MEMORANDUM

PROJECT: Shady Grove Road (north)/Noise Abatement Project
CIP No. 500338

REVIEW TYPE: Forest Conservation Plan and Mandatory Referral No. 06802-DPW&T-1

Attachment 4

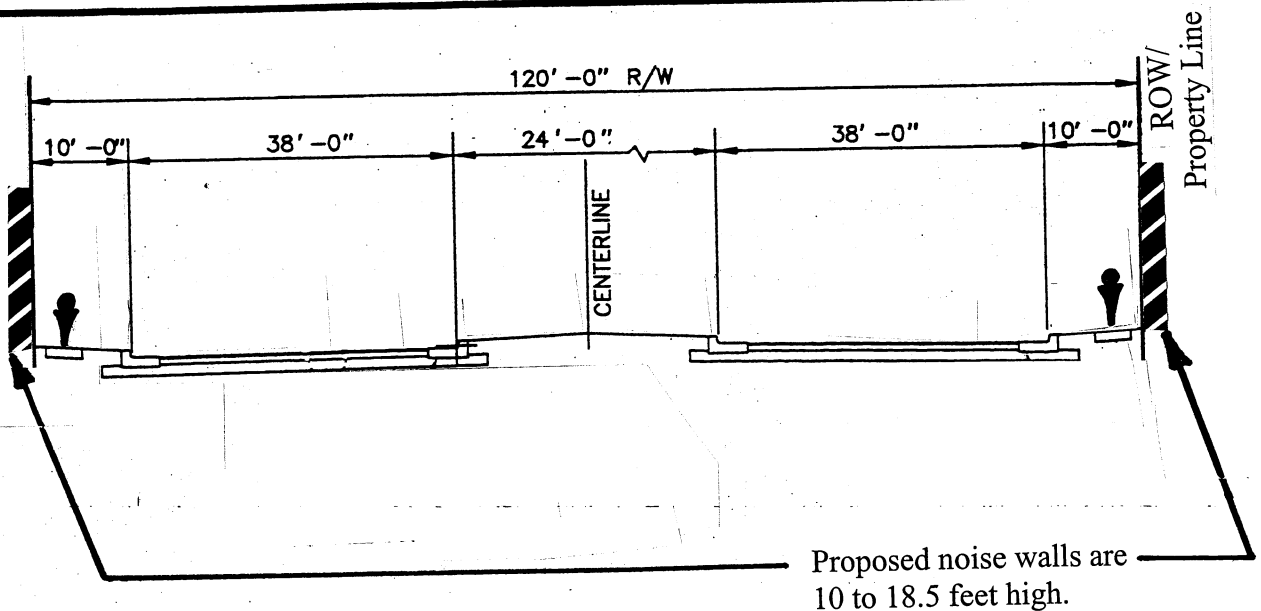
panel separating the sidewalk, and pedestrians, from the road. The pedestrian space may become so constrained, pinned between the curb and the noise wall, that it becomes a very uncomfortable place to be, deterring pedestrian use. In the case of the subject project, the noise walls are taller than the distance between the wall and the curb (see Attachment 4).

While the noise walls are intended to mitigate the negative impacts of a public improvement (the road) on a private homeowner, staff believes that the interests of the general public must still receive appropriate consideration. In addition to the current policy requiring safe pedestrian access, staff recommends that the Highway Noise Abatement Policy be amended to emphasize the importance of landscape screening of noise barriers from the roadway perspective. All reasonable options shall be considered to accomplish this objective, including but not limited to flexibility in elements of the cross section, location of the barrier on private land, and/or other engineering or design adjustments. While any land needed to build the wall would be acquired by DPWT and become additional right-of-way, generally keeping the wall outside the Master Plan roadway right-of-way will ensure that pedestrians have an adequate, safe offset from the roadway and that in most cases there will be room for landscaping to screen the walls and create a more pedestrian-friendly environment.

2. Install any additional lighting needed prior to the construction of sidewalks.
3. Where space is available, provide an eight-foot-wide landscape panel between the curb and the location of the future sidewalk.
